**Group of Experts for the revision of the IMO/ILO/UNECE
Guidelines for Packing of Cargo Transport Units**

Updates on the second draft of the Code of Practice for Packing of Cargo Transport Units

Comments on the second draft of the CTU Code (Chapter 5)

Transmitted by the expert of Japan

1. Information flow path

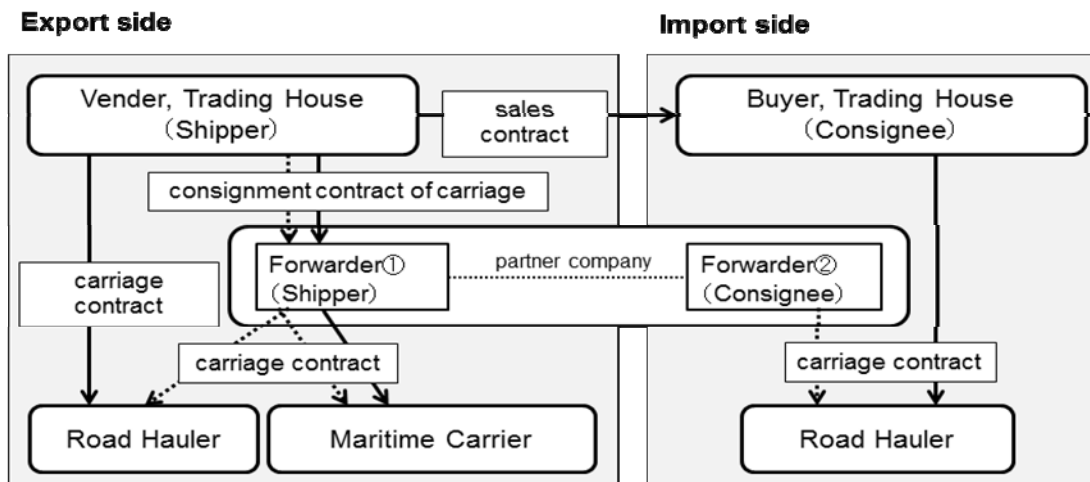
The information flow path described in the 2nd draft doesn't assume that the party other than the shipper arranges road transport. As the result, carriers who execute the road transport in the import side may not acquire the necessary information. Therefore, in case a consignee makes the road transport contract, the rule that the consignee shall transmit the information to the road hauler should be clarified.

Thinking of above problems, the consignee should be added to the party responsible to transmit information because the consignee may make the road transport contract with the carrier. And, the information flow path from the shipper to the consignee should be added for transmitting the necessary information to the consignee. Moreover, the freight forwarder should be added to the party responsible to transmit information as well as the shipper and the consignee, in order to keep the information path to the carrier uninterrupted.

Figure 5-1 : Scope of shipper

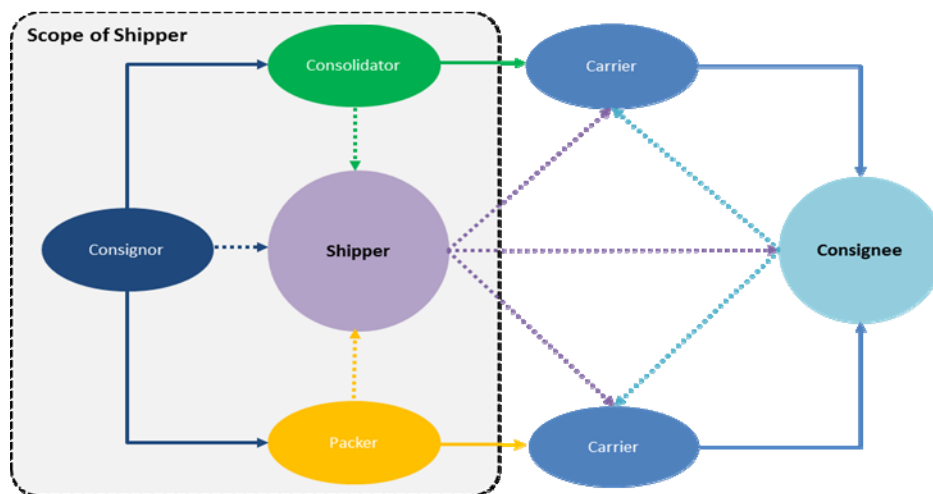
In order to transmit CTU's information to the carrier who executes the transport in the import side, the shipper needs to transmit CTU information to the consignee so that the consignee can transmit the CTU's information to the carrier.

5.2.3.2 **Figure 5-1** shows the scope of the shipper. A shipper may act as the processor of information receiving information about the cargo and the packing details from the consignor and packer / consolidator respectively and transmitting it to the parties involved in the transport of the CTU.
